From: Amanda Scholes on behalf of Planning.Responses
Sent: 01 February 2018 09:45
To: Planning Scanning
Subject: FW: 38848 - (HE ref #4116 / 79420): WA/73/17/OUT: Land East of Wandleys Lane, Fontwell
Attachments: Atkins Land East of Wandleys Lane Technical note_1.0.pdf

Technical note

Project:	Land East of Wandleys Lane	To:	Richard Franklin, David Bowie
Subject:	Lane East of Wandleys Lane Modelling Review	From:	Nii Dodoo
Date:	29 Jan 2018	cc:	Paul Harwood, Chris Cary, Alistair Bradley

Figure 4 Fontwell East Roundabout Proposed Signalisation Layout

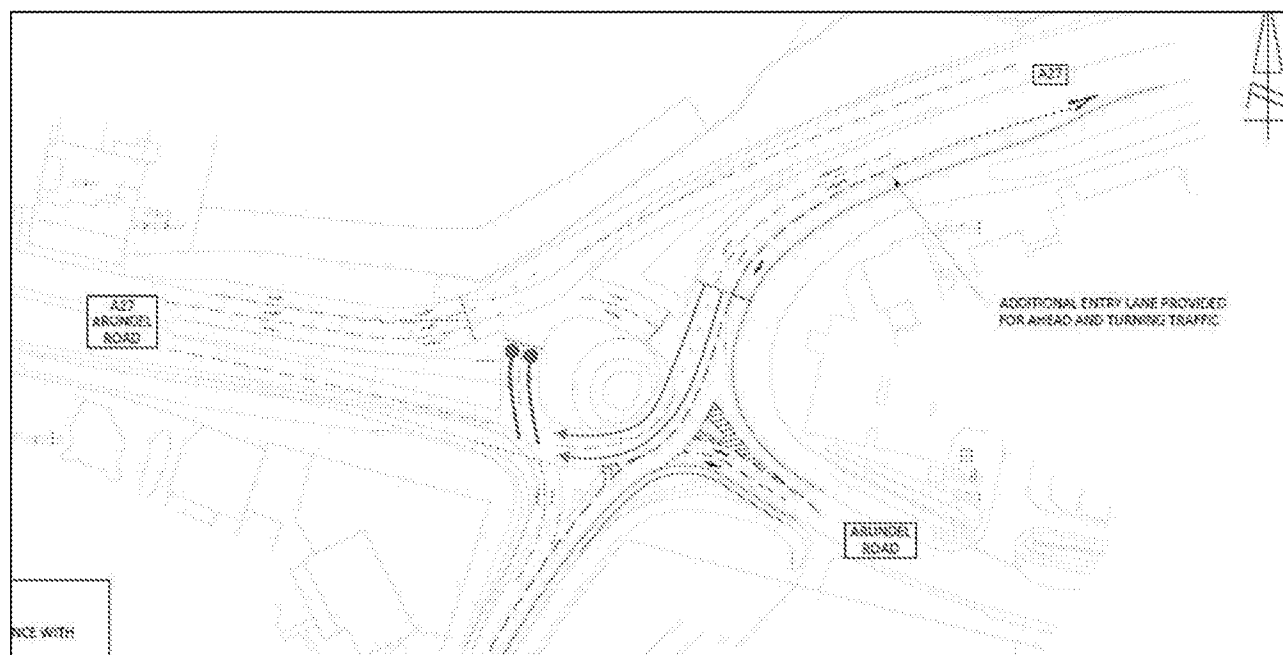
The proposed junction layout with partial signalisation, shown in Figure 4, results in very short circulatory stacking capacity. Based on the queue results in the proposed models, the queues in these short circulatory sections may extend beyond the non-blocking storage. As shown in Figure 4, this could result in a potential hazard if two lanes of traffic from the A27 East runs into the back of a queue on the western circulatory. Depending on the cycle time, staging and phasing, the predicted queues can vary significantly. Cycle time optimisation should be carried out and queue limits should be placed on circulatory sections based on non-blocking storage capacity.

As with the Fontwell East Roundabout, it is recommended that traffic is full assigned to the network, cycle time optimisation and signal optimisation are implemented in the Highways England models without Wandleys traffic flows. Cycle timings should be retained when testing future scenarios with Land East of Wandleys and Land East of Tye traffic flows. Signal timing optimisation should be carried out in all scenarios.
